Project Name: Park Boulevard Extension
Project Number: IFB No. 2024-458
Subject: Change Order #003

Halff recommends the following change order #003 modification to the Park Boulevard Extension project.

PARK BOULEVARD EXTENSION

SHEET 309 OF 502 SST-07

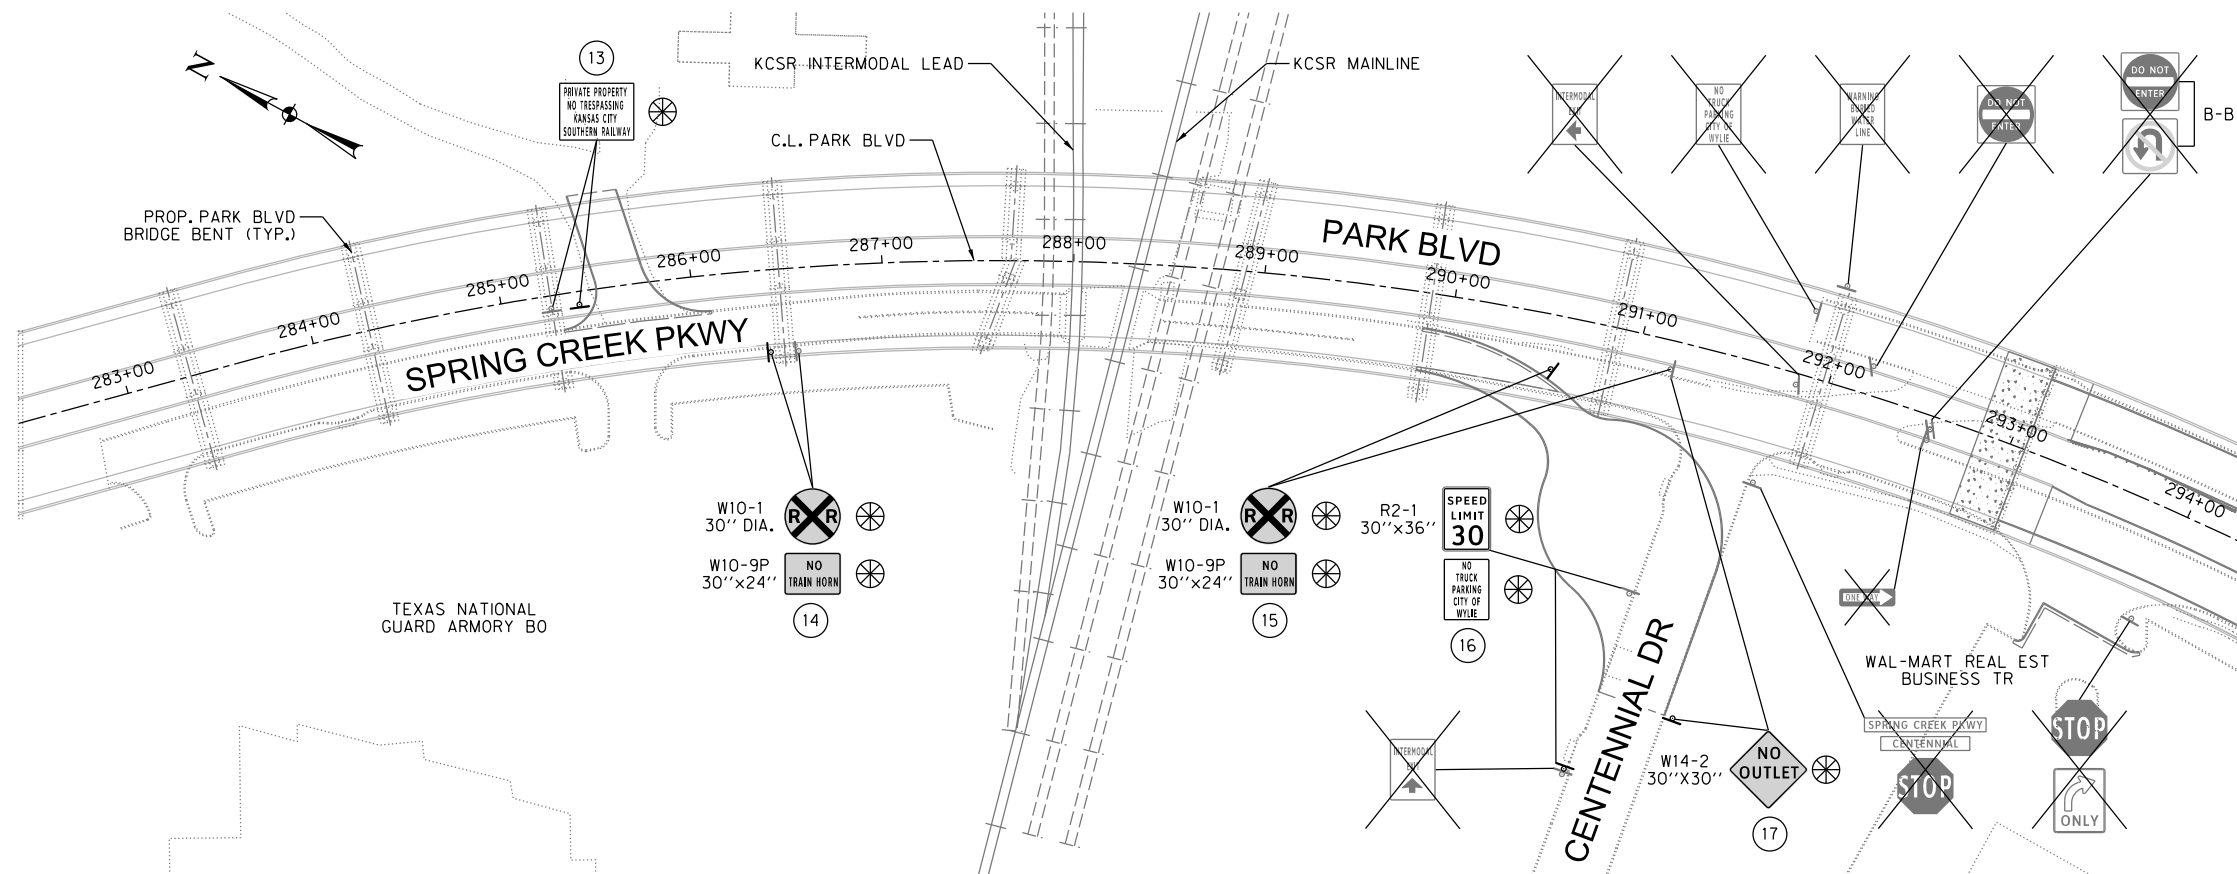
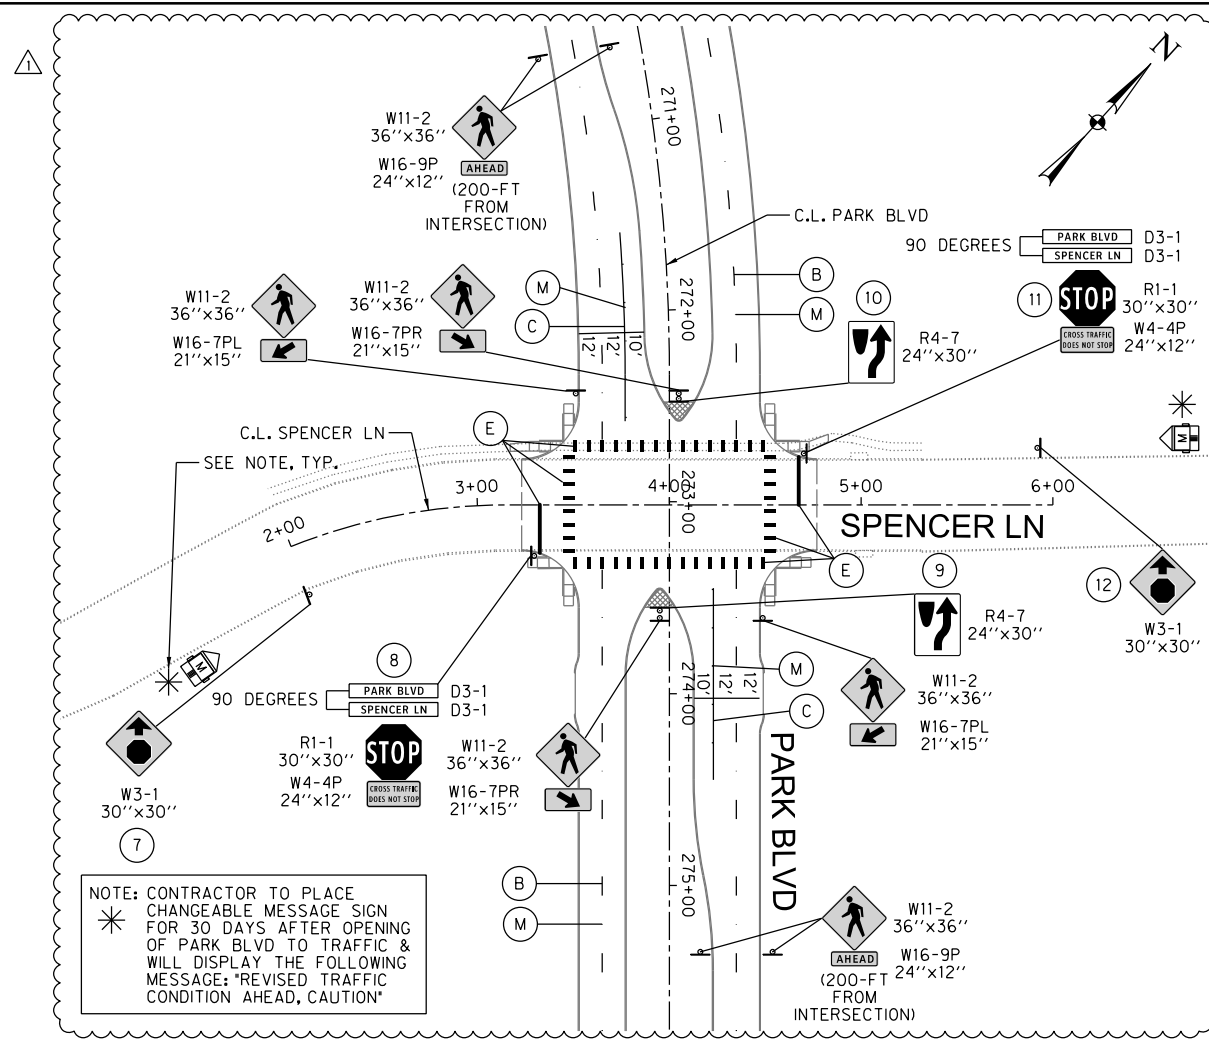
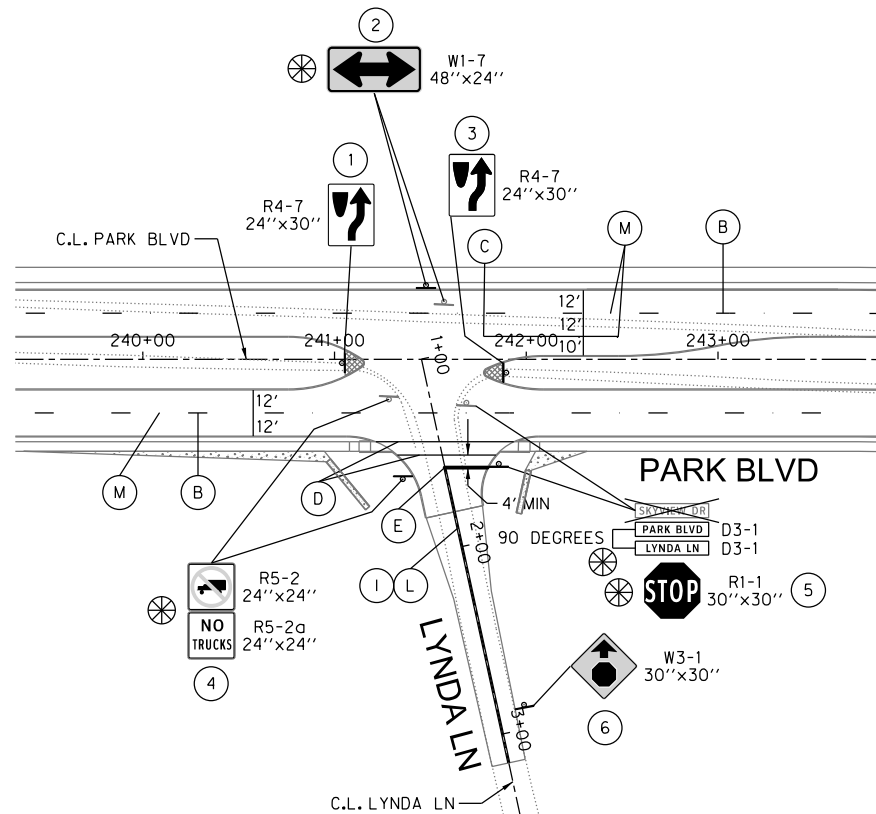
03-12 – REFL PAV MRK TY I (W) 24" (SLD)(100 MIL) – This is a plan quantity adjustment for striping revisions for the four additional crosswalks at the Spencer Lane and Park Boulevard intersection based on the Spencer intersection study.

03-18 – PAV SURF PREP FOR MRK (24") – This is a plan quantity adjustment for striping revisions for the four additional crosswalks at the Spencer Lane and Park Boulevard intersection based on the Spencer intersection study.

1	06/19/2026	PEDESTRIAN CROSSING IMPROVEMENTS (SPENCER STUDY)	AK
No.	DATE	REVISION	APPROV.
